From: [REDACTED]
To: [REDACTED]
CC: [REDACTED]
Sent: 2/24/2021 7:57:22 AM
Subject: RE: O8W-PM 35217268, 35224712, 35224713 - Bucks Creek 1101 Phase 1,2&3 - Pre-Engineering Meeting

Subject: O8W-PM 35217268, 35224712, 35224713 - Bucks Creek 1101 Phase 1,2&3 - Pre-Engineering Meeting

PM 35217268 (Phase 1)

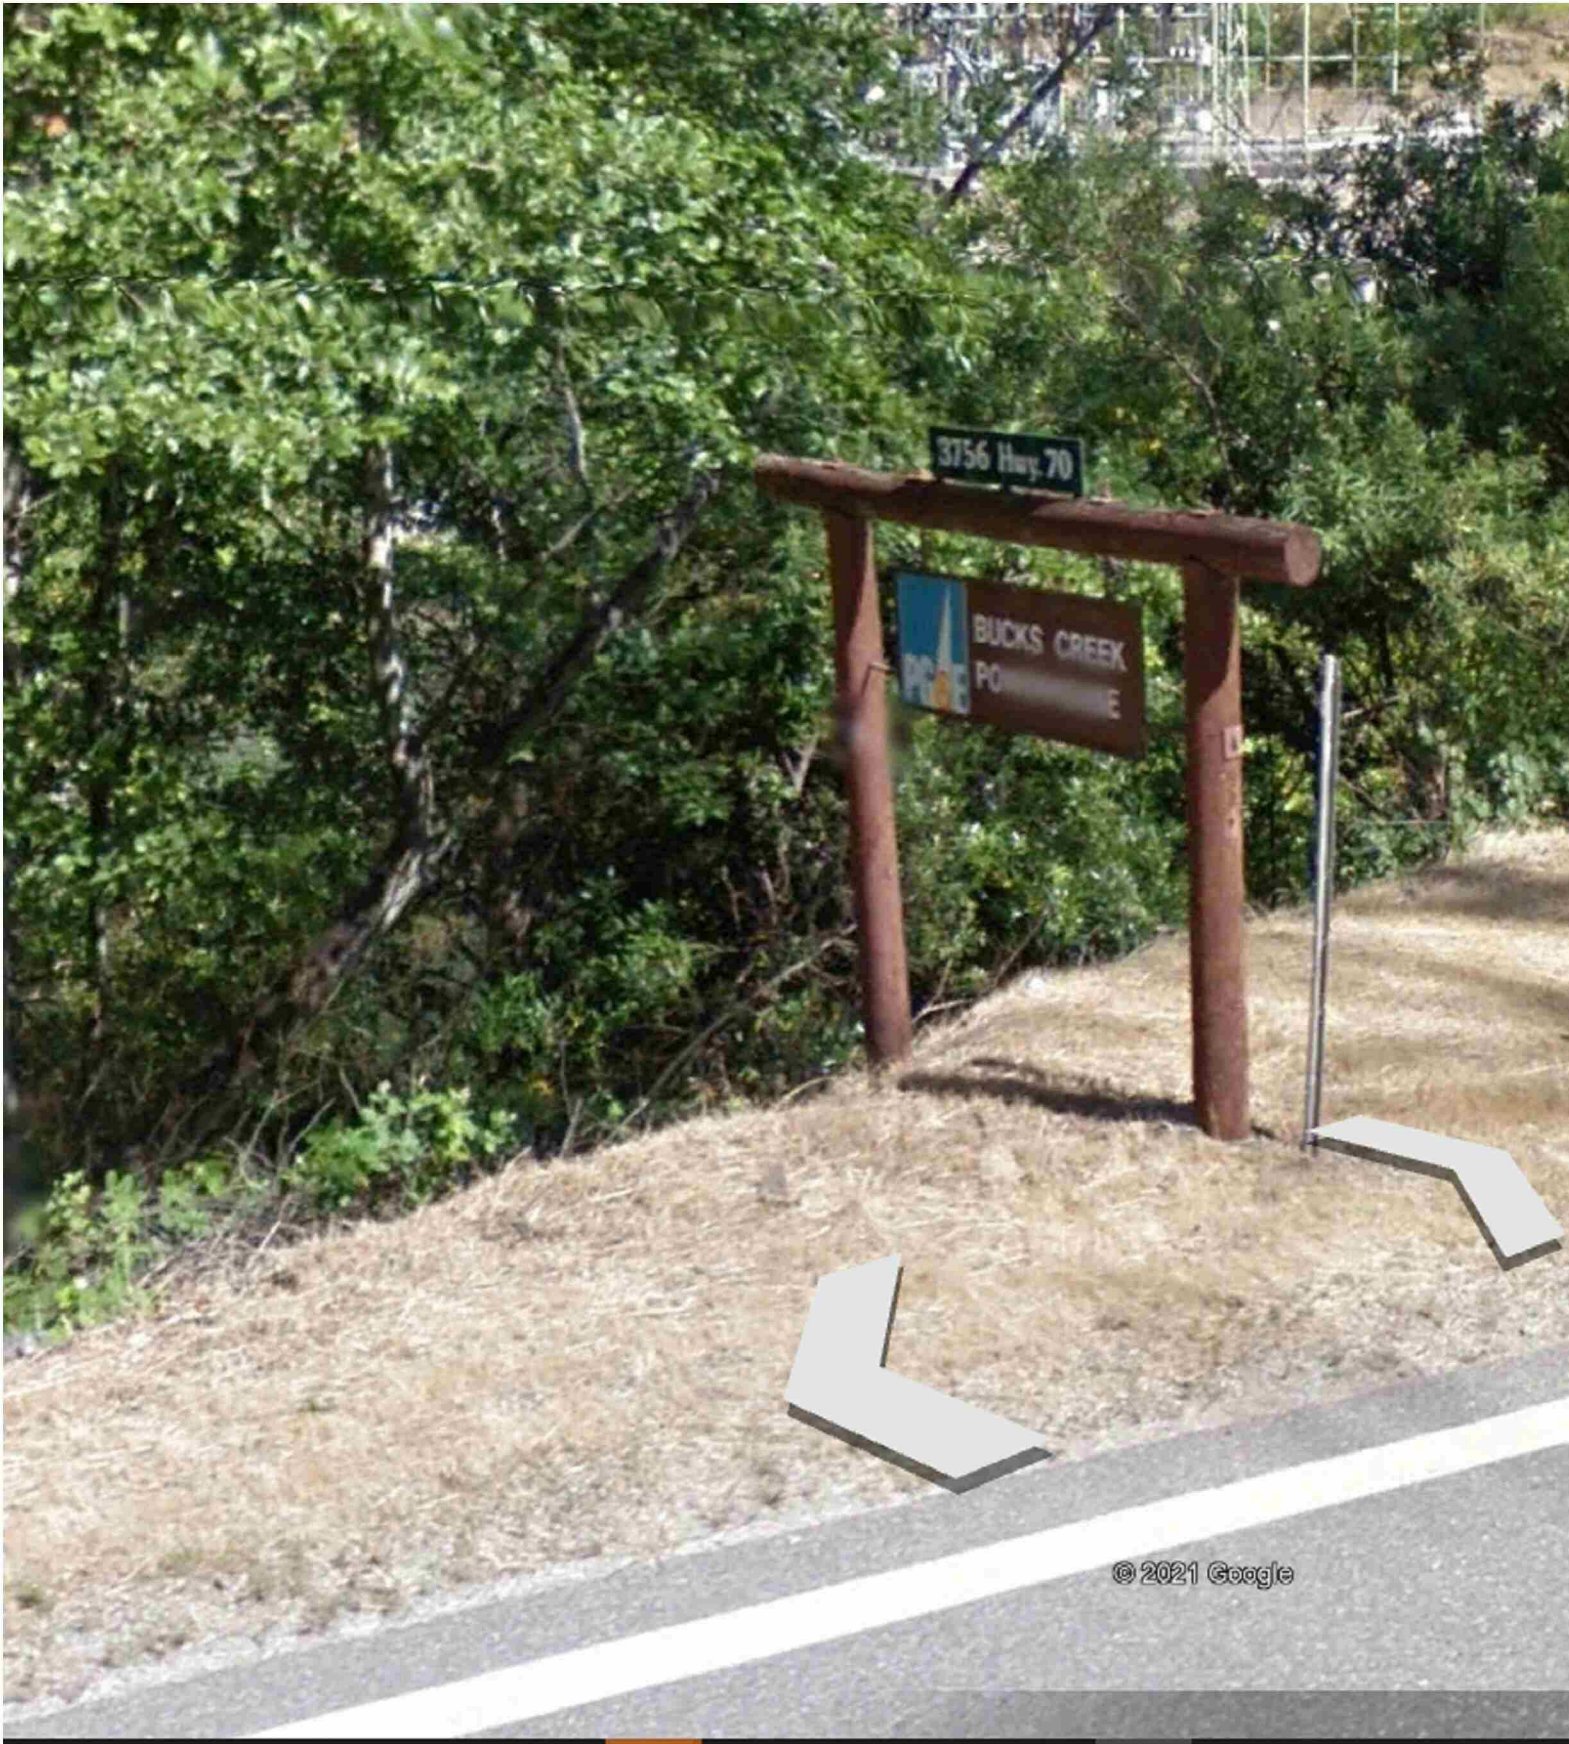
Attached are the 'base-map' limits in a kmz. file. As you will see, we need our base-map to go about ~100' into the tunnel at the south end (see pedestal in picture below....please begin about ~50 beyond this point which is about ~100' beyond the Cresta Dam).
